Abigail Daken, Manager  
ENERGY STAR HVAC Program  
US Environmental Protection Agency Office of Air and Radiation  
1200 Pennsylvania Avenue NW  
Washington, DC 20460

Northeast Energy Efficiency Partnerships (NEEP) appreciates the opportunity to provide comments to the ENERGY STAR program on the Residential Air Source Heat Pump and Central Air Conditioner V6.0 Specification Draft 2. NEEP launched a regional market transformation initiative for air-source heat pumps (ASHP) in 2013. One of the tools that came out of our initiative strategies was the development of the cold-climate air-source heat pump [\(ccASHP\) Specification](#) and [product list](#). The specification development and evolution has been stakeholder driven and is now on its third version. Management of the Specification and product list has offered valuable perspective that is very relevant to this effort to update the ENERGY STAR Criteria for ASHPs, particularly with the inclusion of a new cold-climate category. As part of the management of the ccASHP Specification, NEEP maintains a sub-committee made up of representatives from efficiency programs, technical experts and the designer community to help inform neede

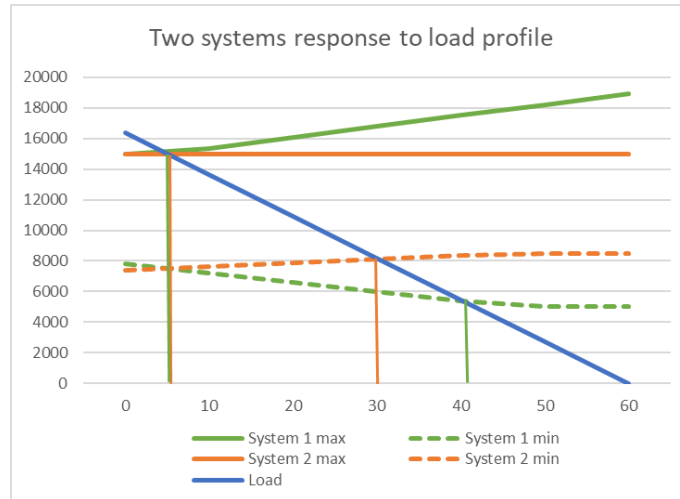
An illustrative example follows. Consider two systems; system 1 has a higher turn-down ratio (lower 47F minimum capacity) even though it has a much lower “capacity maintenance” value:

The maximum (solid) and minimum (dotted) capacities of both machines are plotted against the load line (blue) of a home for which both are sized to meet the design load at 5°F:

The most important element in the maximum capacity plot is where it intersects with the load line; any outdoor temperatures below that intersection will need auxiliary heat or will suffer a temperature drop in the home. For virtually all temperatures above that point, the system will presumably be modulating, until the temperature reaches the point where the minimum capacity curve intersects the load line. Above that temperature, the equipment will not be able to modulate and will cycle, leading to decreased efficiency.

In the example, System 1 has a high turn-down (3) and a lower “capacity maintenance” value; its “cycling limit” is about 42°F. System 3 has a much lower turn-down (1.8), even though its “capacity maintenance” is higher; but the cycling limit temperature is much colder, about 30°F. This system will operate at lower efficiencies for a significant part of the winter (about half of heating hours, assuming the average heating temperature is about 30°F). This suggests that a well-reported (reliable) turn-down ratio is far more important to ensure heating performance over a wide range of temperatures than a simple “capacity maintenance” value. This effect is amplified in cases of oversizing, and further amplified if low-speed performance at 47°F is not achievable in the field.

Alternatively, EPA should consider replacing the 70% capacity requirement with a requirement that is based on the ratio of the maximum capacity at 5°F to the *minimum* capacity at 47°F. To be useful, an additional CVP test that would address performance at low loads and mild temperatures (47°F) would be essential.
